Re: 50 Powder Mill Road
DEP 85-1002

Please find enclosed 3 full and 9 reduced scale copies of the Notice of Intent Amend Plan for the rehabilitation of the building at 50 Powder Mill Road, which have been revised to hopefully conform to our on site discussions of Thursday evening. These documents have also been forwarded to you via e-mail.

**NOTICE OF INTENT
AMEND PLAN**

NOTICE OF INTENT AMEND PLAN
 50 POWDER MILL ROAD
 ACTON, MA 01720

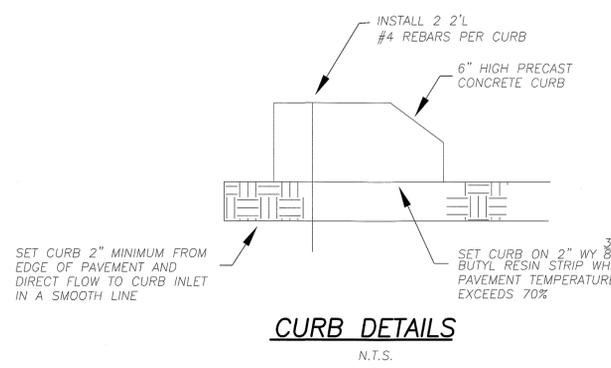
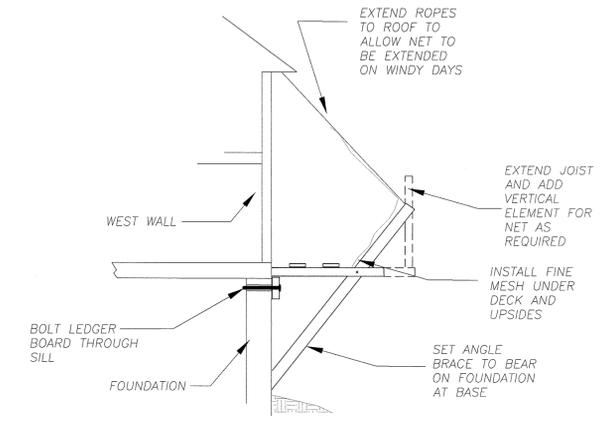
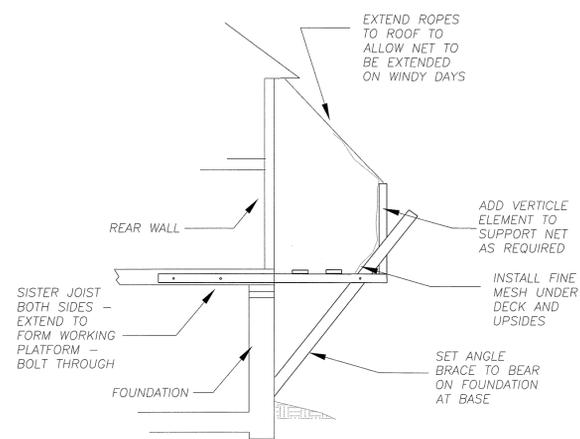
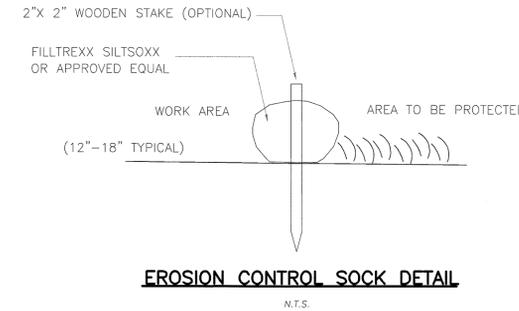
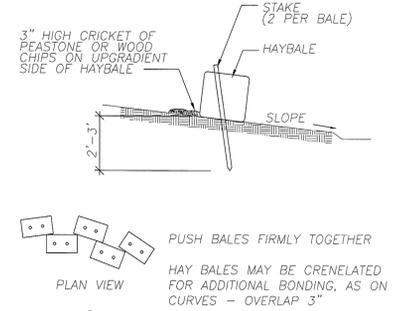
The stone dripline strip has been terminated at the emergency access door at the rear of the building. This is approximately equal to the eastern end of the second window from the dam side of the building.

Porous pavement will be utilized in the loading dock area and to pave the area resulting from the removal of 56 Power Mill Road.

The erosion control plan has been revised to include the environmental safe guards and procedures/restrictions we discussed on site.
